BRIDGESTONE by *Rockford* Service Letter

BSG-0002

DRY CHARGED STORAGE BATTERIES

SPARK PLUG RECOMMENDATIONS

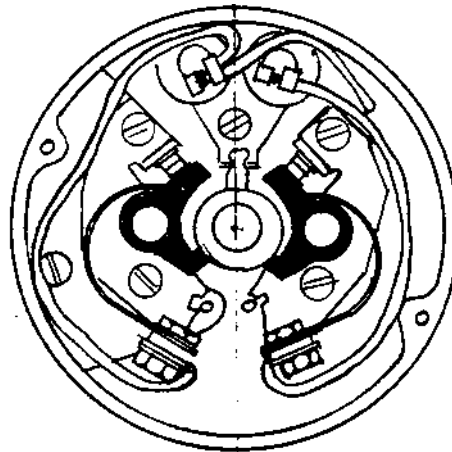
Various changes to the points, condenser and generator have been made since the beginning of production of the BS 175. Below are shown the 3 types of generators. Always check the type of generator involved to be sure the correct parts are being used. The generator can be identified by matching the point type and location to one of the illustrations below. Listed with each type of generator are the parts to be used for that generator.

Shown below is an illustration of the generator with the cap removed to expose the points and condenser. This type of generator was used on all B/S 175 DT before Serial No. 16G-11760.

PART NO.	DESCRIPTION	NO REQ'D
1703-8000	A.C. Dynamo	1
1736-8000	Breaker Cam (Double Lobe)	1
1752-8000	Left Contact Breaker Assembly	1
1753-8000	Condenser (Double Unit)	1
1757-8000	Right Contact Breaker Assembly	1
1741-8000	Timing Gear	1

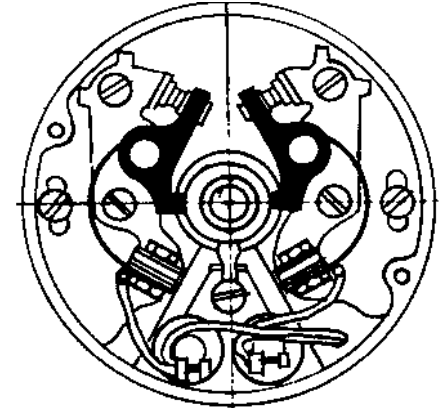
Shown below is an illustration of the generator with the cap removed to expose the points and condenser. This type of generator is used on all B/S 175 DT and B/S 175 HS after Serial No. 16L-20758.

<u>PART NO.</u>	<u>DESCRIPTION</u>	<u>NO REQ'D</u>
1703-8002	A.C. Dynamo After 16L	1
1736-8001	Breaker Cam, Single Lobe	1
1739-8001	Breaker Cover	1
1751-8001	Breaker Base	1
1752-8001	Left Contact Breaker	1
1753-8000	Condenser (Double Unit)	1
1757-8001	Right Contact Breaker	1

BS350 CLUTCH CHANGE

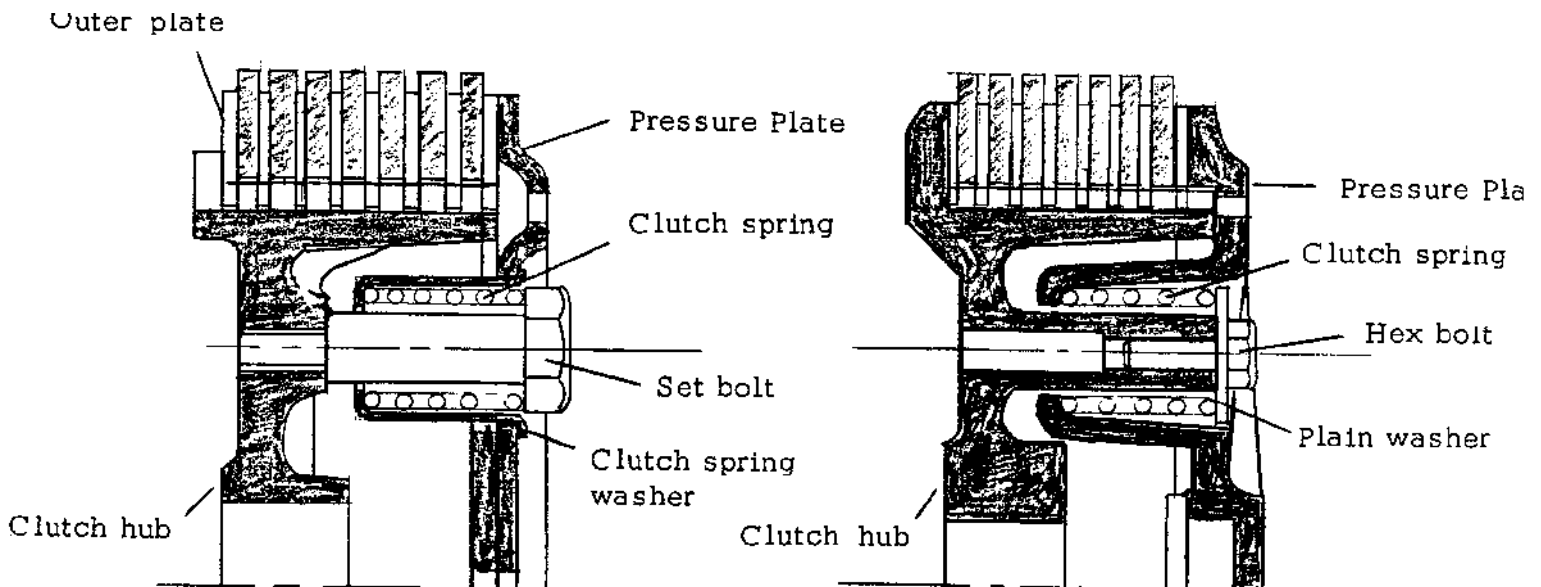
The clutch assembly on the BS 350 GTR has been modified after Serial No. 21S01022.

The parts that are effected are listed below with sketches so that you may identify these new parts.

INDEX	BEFORE SERIAL NO. 21S01022			AFTER SERIAL NO. 21S01022		
<u>NO.</u>	<u>PART NO.</u>	<u>NAME</u>	<u>QTY</u>	<u>PART NO.</u>	<u>NAME</u>	<u>QTY</u>
9-1	2211-9000	Pressure plate	1	2211-9001	Pressure plate	1
9-2	2213-9000	Clutch spring washer	6	Not used		-
9-4	2215-9000	Inner plate	6	2215-9000	Inner plate	7
9-5	2216-9000	Outer plate	1	Not used		-
9-6	2218-9000	Clutch spring	6	2218-9001	Clutch spring	6
9-7	2219-9000	Set bolt	6	0113-0616	Hex bolt A	6
9-8	2221-9000	Clutch hub	1	2221-9001	Clutch hub	1
9-26	-	-		09040-112	Plain washer	6

FIELD MODIFICATION #1 - USING SPECIAL OUTER PLATE (2216-9010)
(BEFORE SERIAL NO. 21S01022)

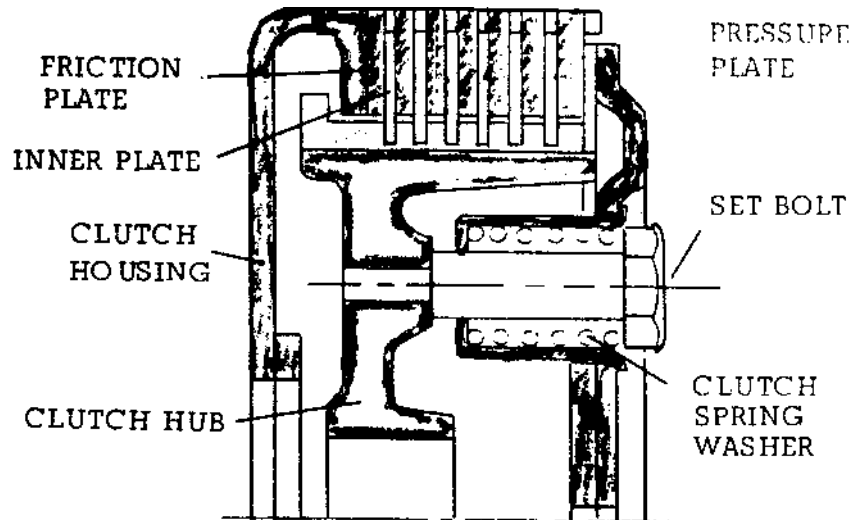
The factory is now adding (after serial number 21V04000) a new outer plate (2216-9001) and carburetor cover grommet (2195-9010). This eliminates any objectionable clutch noise and has the unexpected advantages of making the clutch even smoother to operate and unaffected by temperature. Most models manufactured before this factory modification, when shipped from Rockford after October 15, will have been modified by making a similar modification, using new outer plate (2216-9010). You will be able to determine whether the unit has been modified by the grommet at the bottom of the rear edge of the right carburetor cover. If the unit has not been modified, modification kit SC1522 is available on special order from Rockford after October 15. The modification kit includes:

<u>PART NO.</u>	<u>NAME</u>	<u>QTY</u>
2211-9000	Pressure Plate	1
2213-9000	Spring Washer	6
2214-9000	Friction Plate	7
2215-9000	Inner Plate	6
2216-9000	Outer Plate	Not Used
2218-9000	Clutch Spring	6
2219-9000	Set Bolt	6
2221-9000	Clutch Hub	1
2216-9010	Special Outer Plate	1
2195-9010	Grommet	1

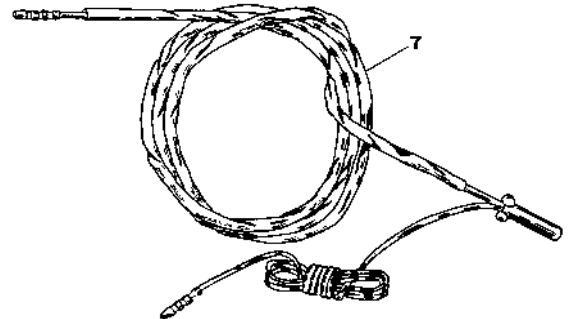
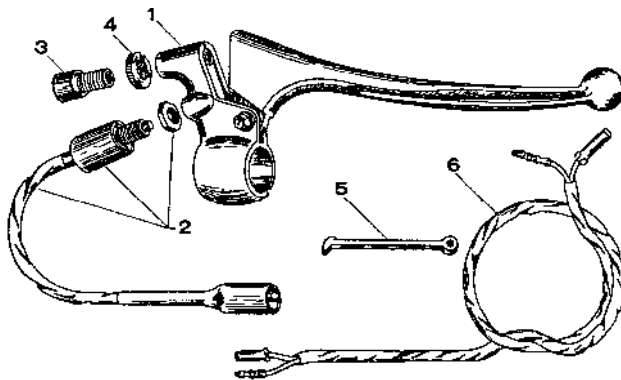
To comply with our standard policy of constantly improving Bridgestone motorcycles, we are now putting heavy-duty handlebars on the Bridgestone 100 TMX. After serial number 22P, the size of the handlebar was increased from 3/4" to 7/8". When ordering TMX parts, please note that the following parts are not interchangeable.

ITEM	PART NUMBER FOR	
	3/4" Handlebar	7/8" Handlebar
Front Fork Assembly	4100-5600 MS	4100-5610 MS
Handlebar	4511-5040	4511-8020
Upper Bridge	4161-3210	4161-3220
Handlebar Holder	4162-3200	4162-3210
Right Grip Assembly (see below)	6104-5610	6104-8200
Left (clutch) Grip Assembly (see over)	6101-5600	6101-9000
Throttle Cable	6176-5081	6176-5610
